Planning Commission Regular Meeting | 5:30 PM

Wednesday, January 14, 2026

Town Hall / Council Chambers - 302 Pine St Minturn, CO

C. Maloit Park Exemption Tract A Eagle County School District Subdivision - Preliminary Plat

SHEET NO.
C1.1

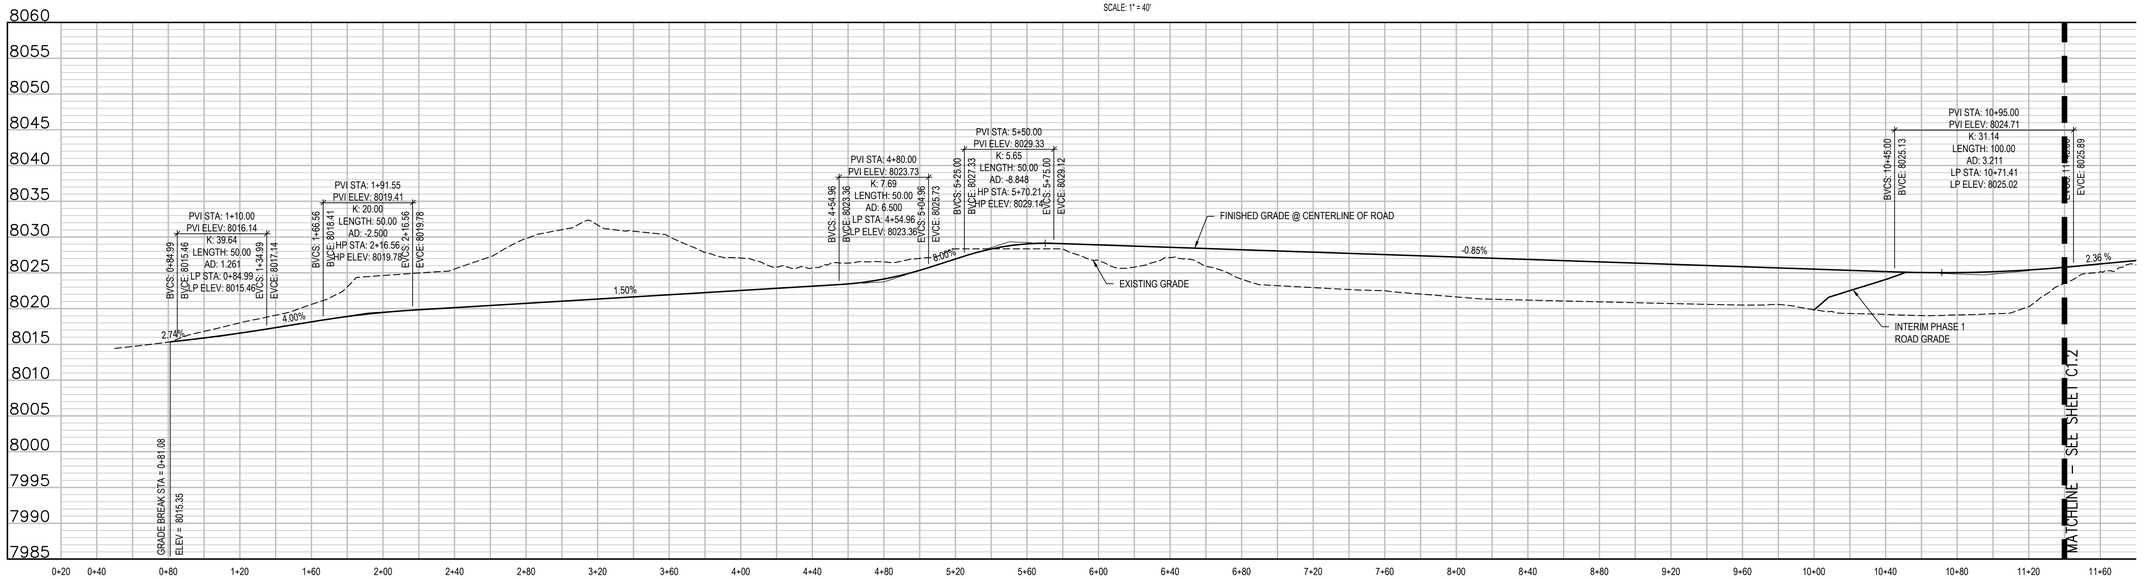
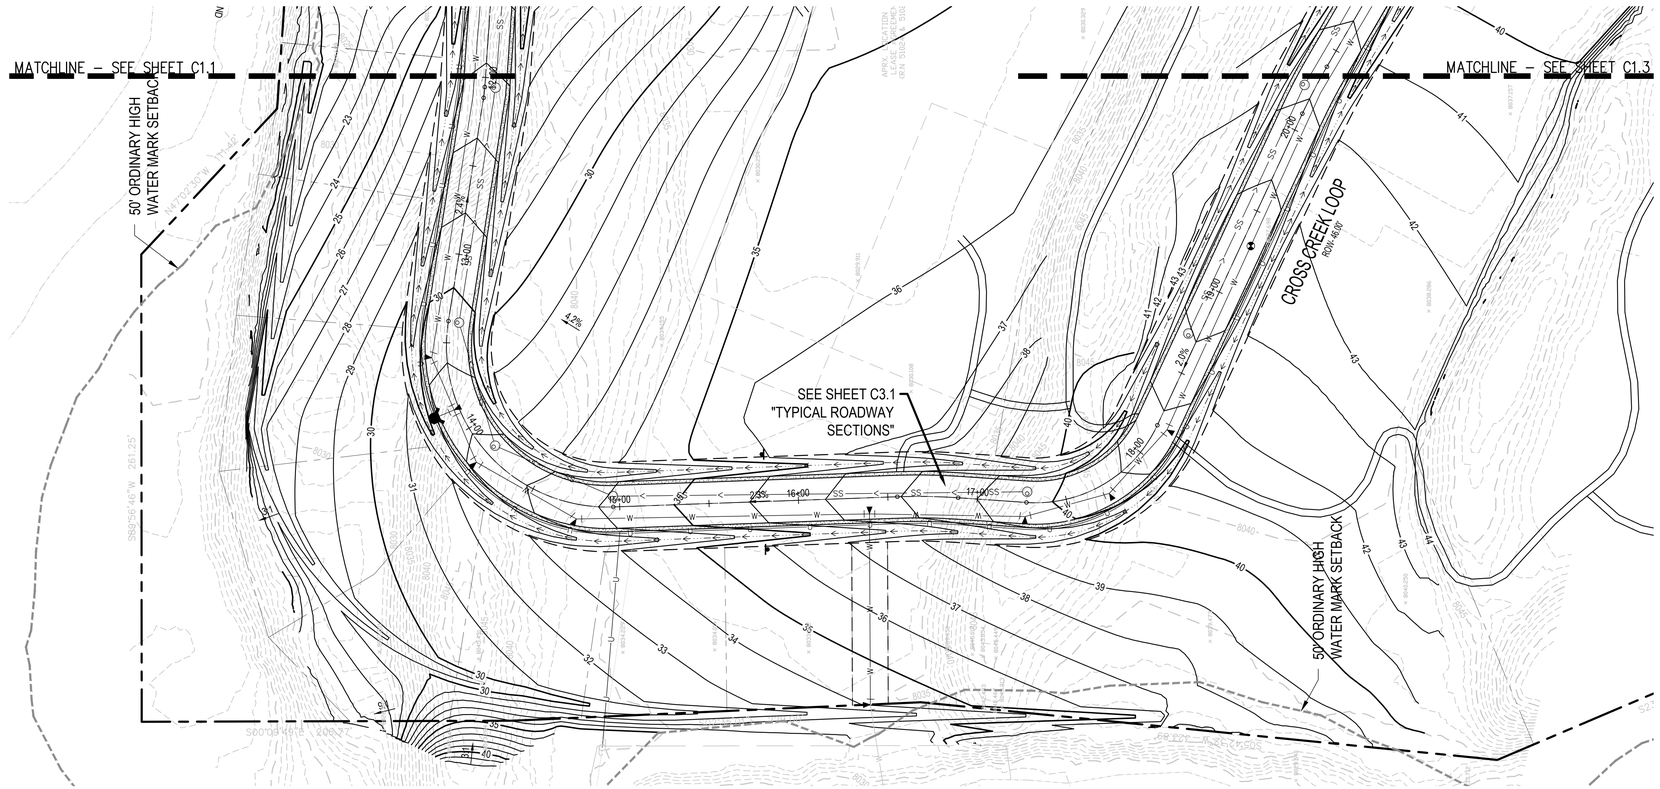
On Sheet No. C1.1 – Cross Creek Loop Plan and Profile, the road names differ from what is shown on the plat. This should be corrected to align with the preliminary plat.

SHEET NO.
C1.2

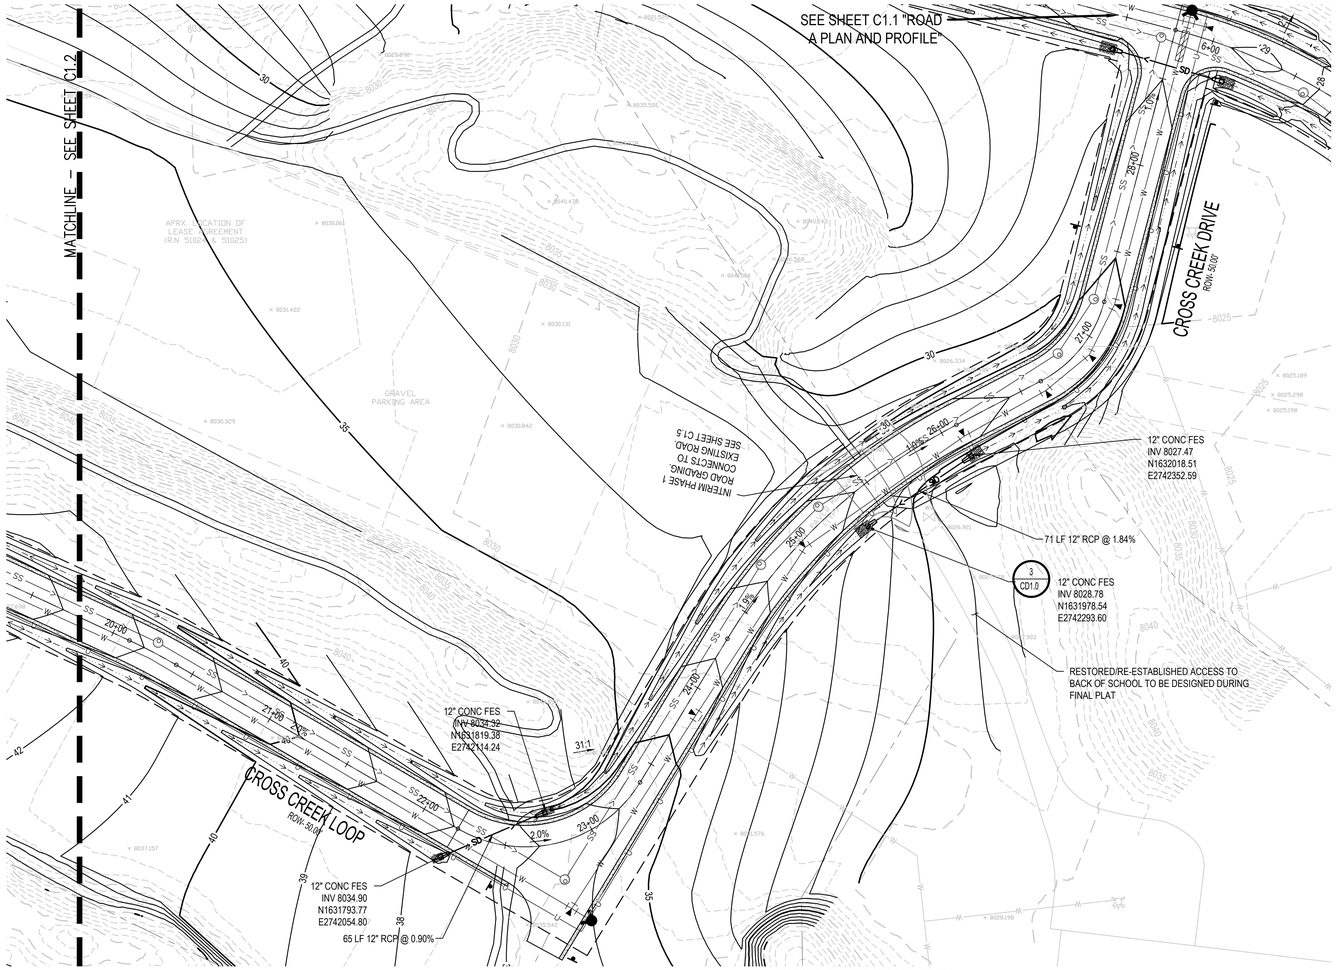
On Sheet No. C1.2 – Road A Plan and Profile, the line with the "U" labeling should read "UE" for underground electric according to the design legend on Sheet No. C0.1. Additionally, the meaning of the hatched lines should be identified on this sheet or removed. If the hatched lines indicate structures or facilities to be demolished, if possible, these should be shown only on the demolition plans and not in the remainder of the Plan Set sheets. Please remove any repetitive hatched lines from the construction plans.
